## SERVICE LETTER 272

### 2 AMP CIRCUIT BREAKER REPLACEMENT ON FIRE BOSS

<b>Aircraft Makes/Model(s):</b>	<b>Float Model(s):</b>	<b>Compliance:</b> Optional	<b>By:</b> MAS
Air Tractor AT-802A & AT-802	Wipaire Fire Boss Conversion 10000A Floats & Landplane	<b>Part Number:</b> 1012836	<b>Approved:</b> DRH
		<b>Date:</b> 4/29/2025	<b>Revision:</b> B

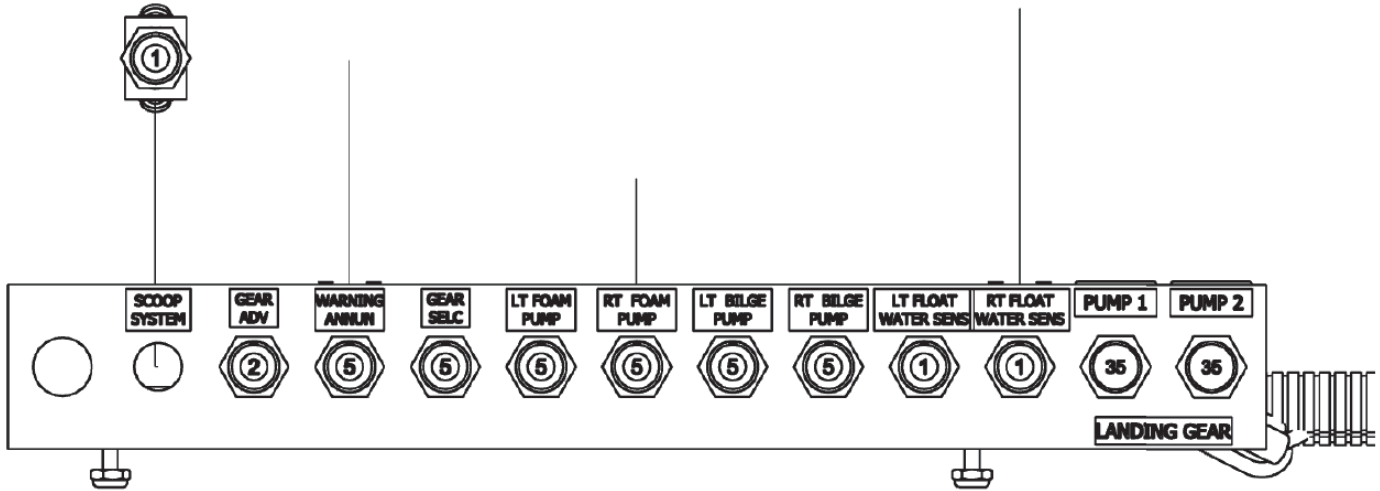
1. Position and prepare aircraft for safe maintenance.
2. Disconnect aircraft battery.
3. Locate the auxilliary circuit breaker panel and remove the top cover by removing the two Phillips head screws.

4. Locate the 1 amp scoop system breaker and remove it by undoing the 1/2 inch nut on the front plate, and the two flat head screws on the back side, one for the wire ring terminal, the other on the ground rail.

5. Install the 2 amp circuit breaker, part number 7277-2-2, by performing the previous steps in reverse.
